TRANS/WP.29/2003/34  
4 April 2003

World Forum for Harmonization of Vehicle Regulations (WP.29)  
(One-hundred-and-thirtieth session,  
24-27 June 2003, agenda item 4.2.26.)

**PROPOSAL FOR DRAFT SUPPLEMENT 2  
TO REGULATION No. 113**

(Headlamps emitting a symmetrical passing beam)

"Annex 2

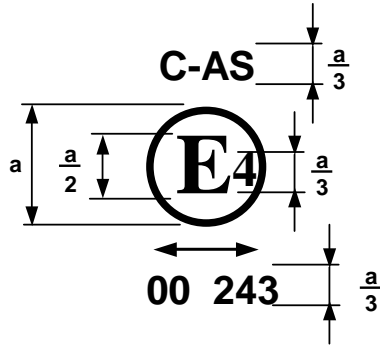
Annex 2, amend to read:

$a \geq 5$  mm for Class A headlamp

$a \geq 8$  mm for Class B, C and D headlamp

Figure 11

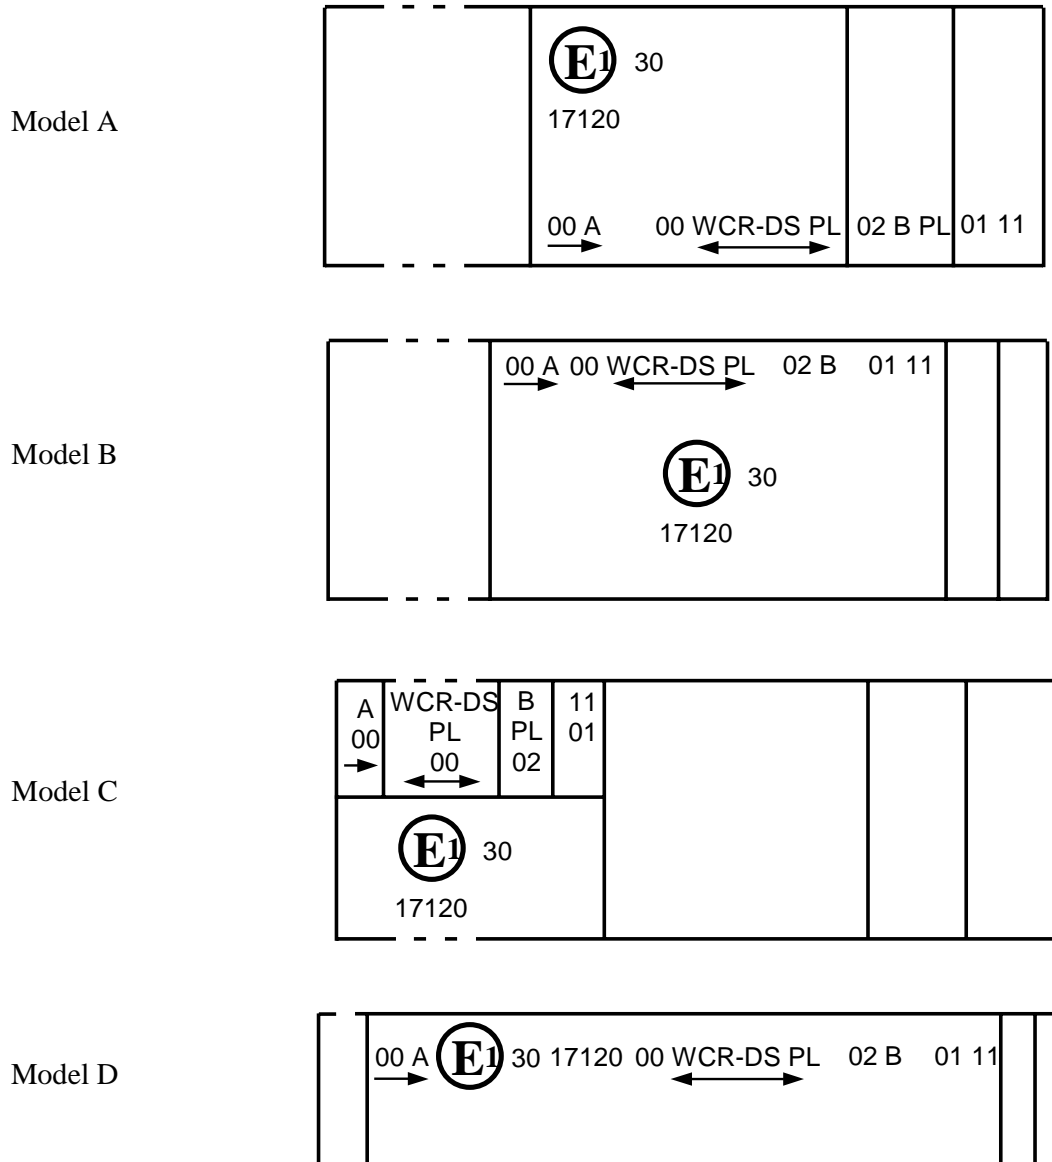
4.3.2.5. Annex 2, figure 11, to this Regulation gives examples of arrangements of approval marks for grouped, combined or reciprocally incorporated lamps with all the above-mentioned additional symbols.

Note: The four examples above correspond to a lighting device bearing an approval mark comprising:

A front position lamp approved in accordance with Regulation No. 50 in its original form (00),

A headlamp, Class D, with a passing beam and a driving beam with a maximum intensity comprised between 86 250 and 101 250 candelas (as indicated by the number 30), approved in accordance with the requirements of this Regulation in its original form (00) and incorporating a lens of plastic material,

A front fog lamp approved in accordance with the 02 series of amendments to Regulation No. 19 and incorporating a lens of plastic material,

A front direction indicator lamp of category 11 approved in accordance with the 01 series of amendments to Regulation No. 50.

Figure 12

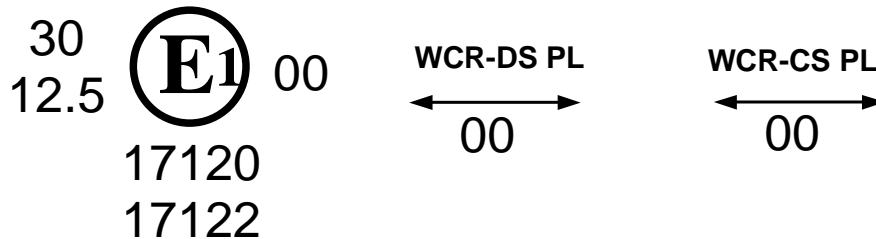
4.3.3.2. Annex 2, figure 12, to this Regulation gives examples of arrangements of approval marks relating to the above case."

The above example corresponds to the marking of a lens of plastic material intended to be used in different types of headlamps, namely:

Either A headlamp, Class D, with a passing and a driving beam with a maximum luminous intensity comprised between 86 250 and 101 250 candelas (as indicated by the number 30), approved in Germany (E1) in accordance with the requirements of this Regulation in its original form (00), which is reciprocally incorporated with a front position lamp approved in accordance with Regulation No. 50 in its original form (00);

Or A headlamp, Class C, with a passing beam and a driving beam with a maximum luminous intensity comprised between 33 750 cd and 45 000 cd (as indicated by the number 12.5), approved in Germany (E1) in accordance with the requirements of this Regulation in its original form (00), which is reciprocally incorporated with the same front position lamp as above;

MEASURING SCREEN  
for Class C and D headlamps  
(Dimensions in mm with screen at 25 m distance)

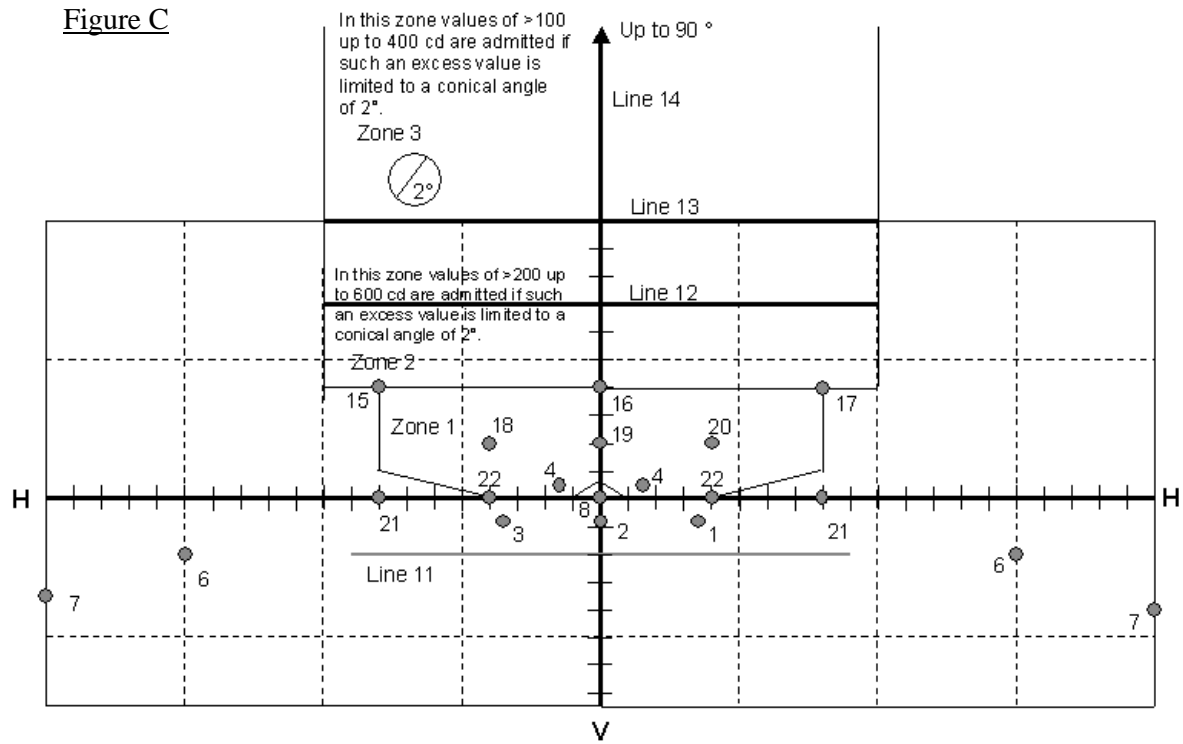
"6.2.5. The illumination produced by the passing beam on the screens in annex 3 shall meet the following illumination requirements:"

6.2.6. The light shall be as evenly distributed as possible within zones 1, 2, and 3 for Class C or D headlamps."

Annex 3, amend to read:

Figure D  
Primary Driving Beam

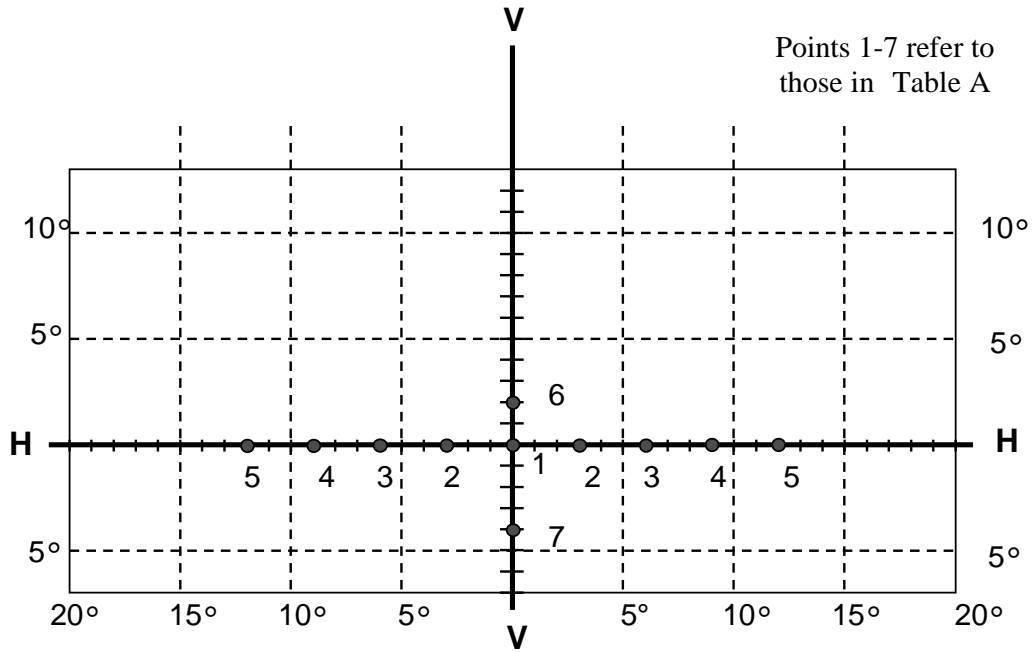
Table A - Primary high beam headlamp

Refer to Figure D for details of test point positions

Figure E  
Secondary Driving

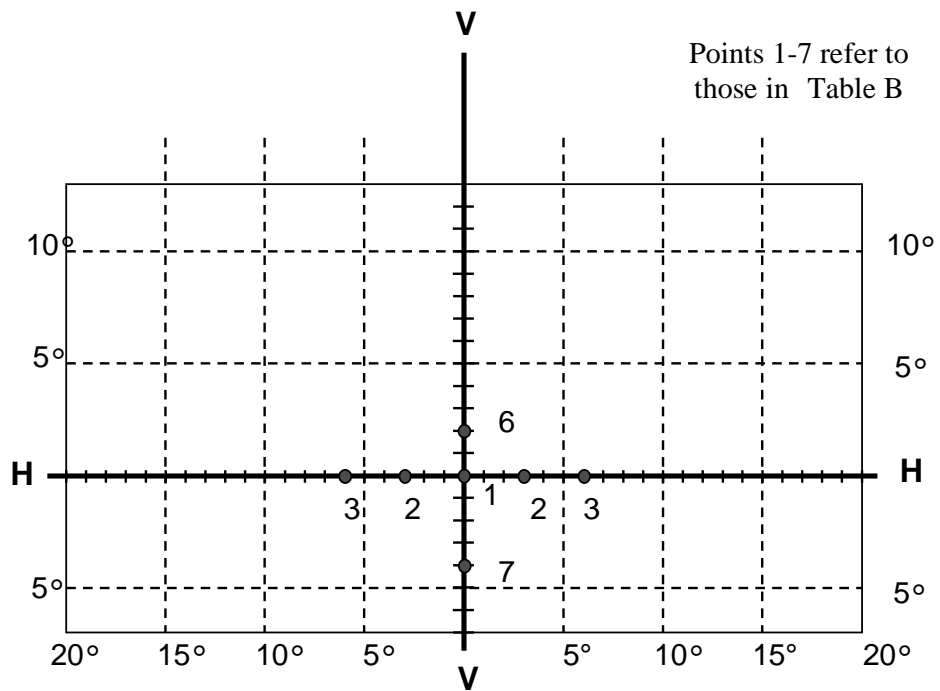
Table B -Secondary high beam headlamp operated with a harmonized passing beam headlamp or a primary driving beam headlamp

Refer to Figure E for details of test point positions
